**Recommendations on the transport of dangerous goods
Manual of Tests and Criteria
(Sixth revised edition)**

Corrigendum

8. Section 38.3, paragraph 38.3.4.4.2, Figure 38.3.4.2

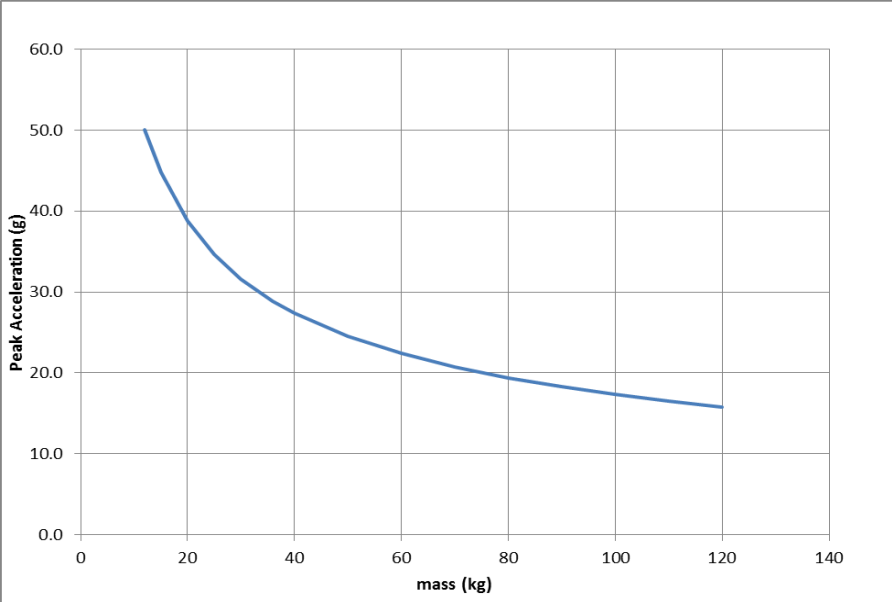
For the existing Figure, *substitute*
